Subject: **Bid No. 8691-J6 –Water Main Improvements–Chandler+May Street / DPW**

**ADDENDUM NO. 2**

| THRUST BLOCK DETAILS<br>TYPICAL<br>CITY OF WORCESTER<br><br>Department of Public Works<br>No Scale<br>Water Operations | Rev. no.           | by          | date |

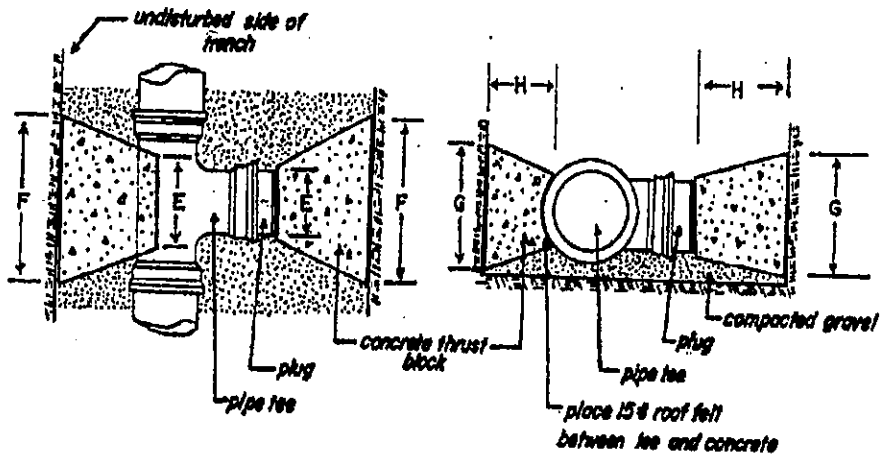
Q34. Please provide thrust block details and dimensions for all pipe sizes on the project.

*A34. See attached figures for thrust block details and dimensions for up to 24-inch diameter pipes. These figures will replace the City of Worcester Department of Public Works & Parks Standard Construction Specifications and Details for this project. Thrust blocks for water main larger than 24-inch diameter will need to be sized in the field based on available underground space.*

Figure No. ADD-2 Project Area  
Chandler Street Water Main  
Improvements and Large  
Diameter Valve Replacements  
Worcester, Massachusetts

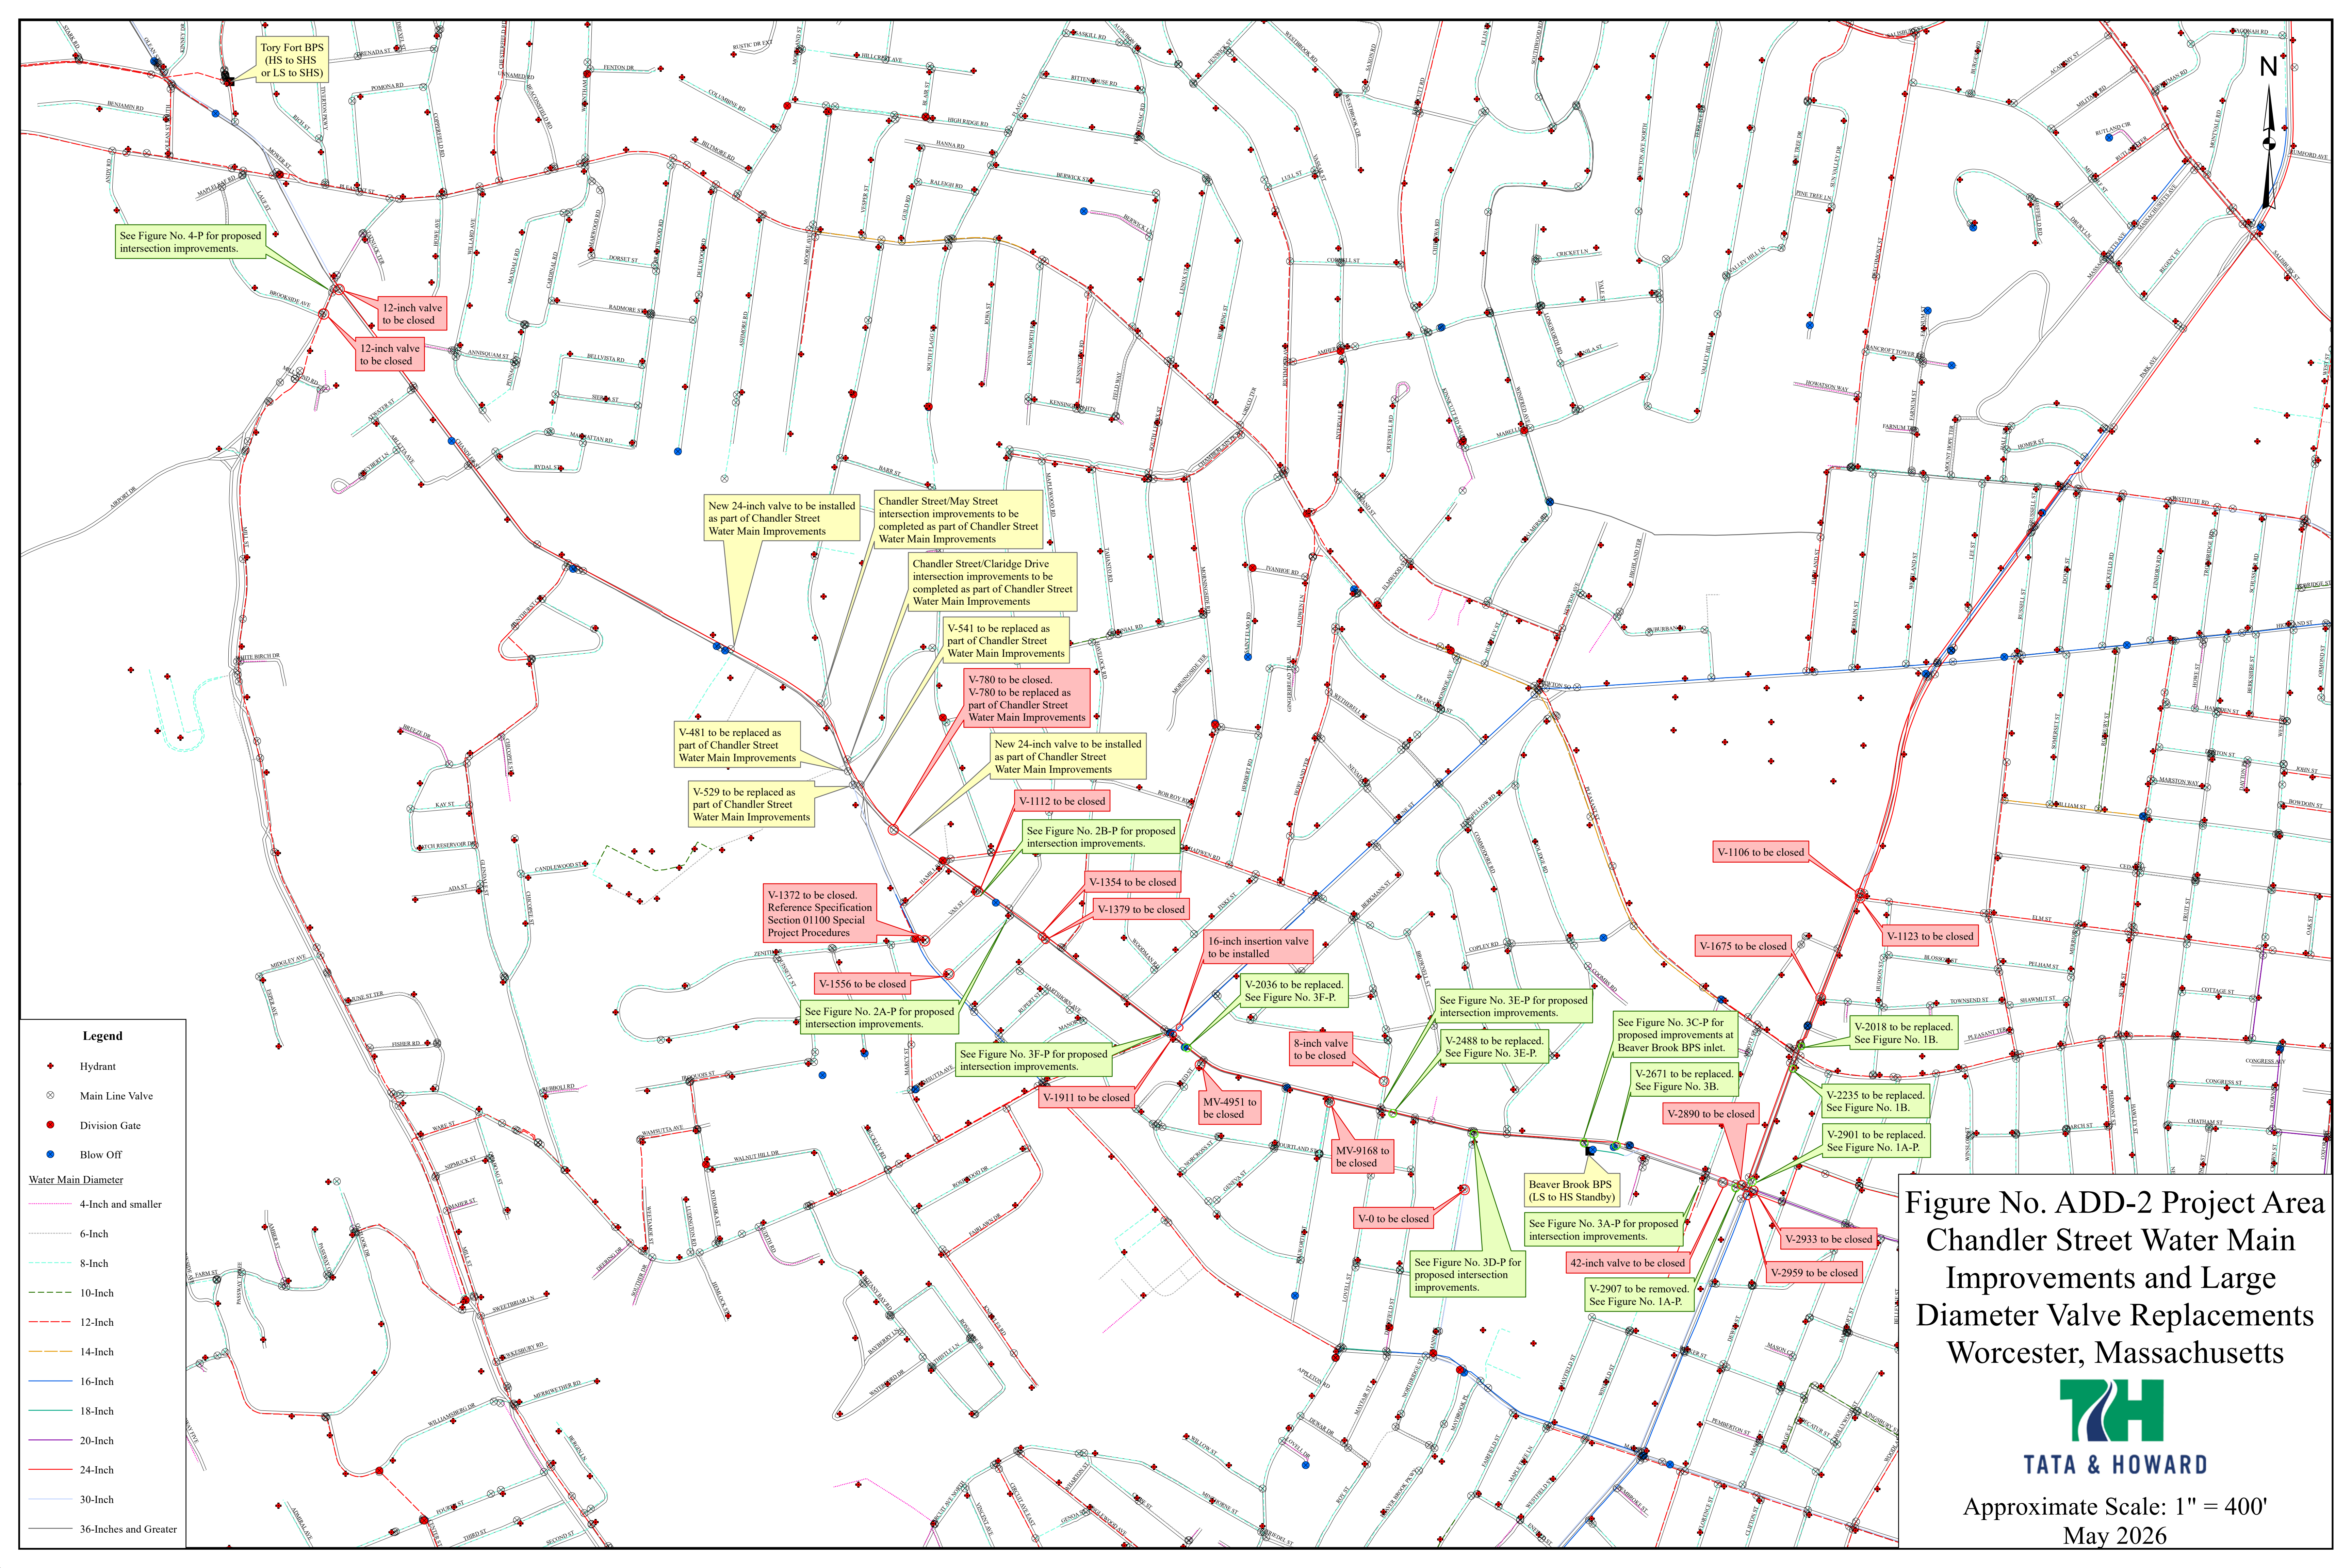
Q21. Can a distribution map of the entire job with all the valve cut ins be provided?

*A21. Yes, see attached Figure No. ADD-1 Project Area.*
